SUNDRY NOTICES AND REPORTS ON WELLS
Do not use this form for proposals to drill or to re-enter an abandoned well. Use form 3160-3 (APD) for such proposals.

8. Well Name and No.
SALADO DRAW 29 26 33 FED COM 2H

Delaware Basin
Changes to APD for Federal Well

Summary of Changes to APD Submission

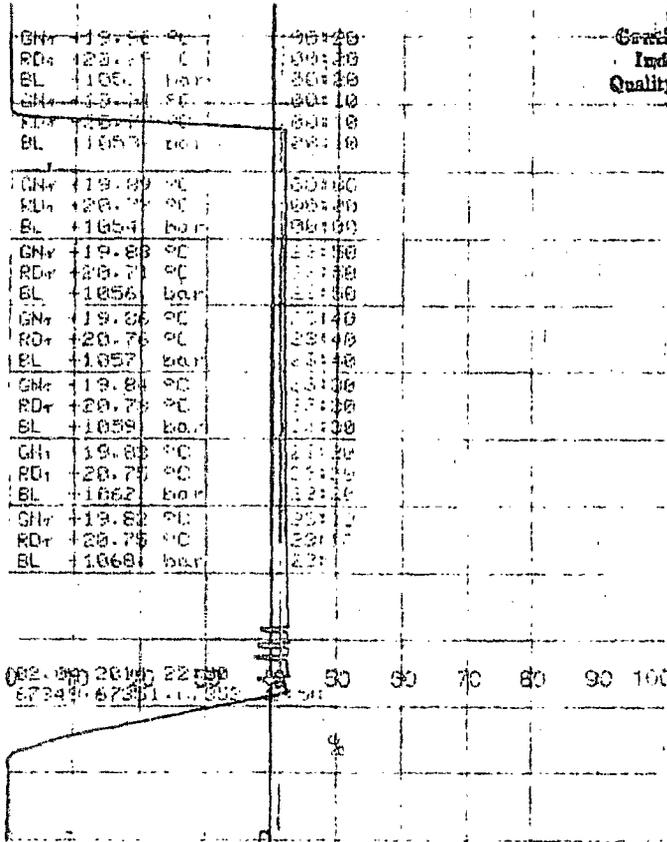
Chevron requests a variance to use a CoFlex hose with a metal protective covering that will be utilized between the BOP and Choke manifold. Please refer to the attached testing and specification documents.

Variance approved to use flex line from BOP to choke manifold. Check condition of flexible line from BOP to choke manifold, replace if exterior is damaged or if line fails test. Line to be as straight as possible with no hard bends and is to be anchored according to Manufacturer's requirements. The flexible hose can be exchanged with a hose of equal size and equal or greater pressure rating. **Anchor requirements, specification sheet and hydrostatic pressure test certification matching the hose in service, to be onsite for review.** If the BLM inspector questions the straightness of the hose, a BLM engineer will be contacted and will review in the field or via picture supplied by inspector to determine if changes are required (operator shall expect delays if this occurs).
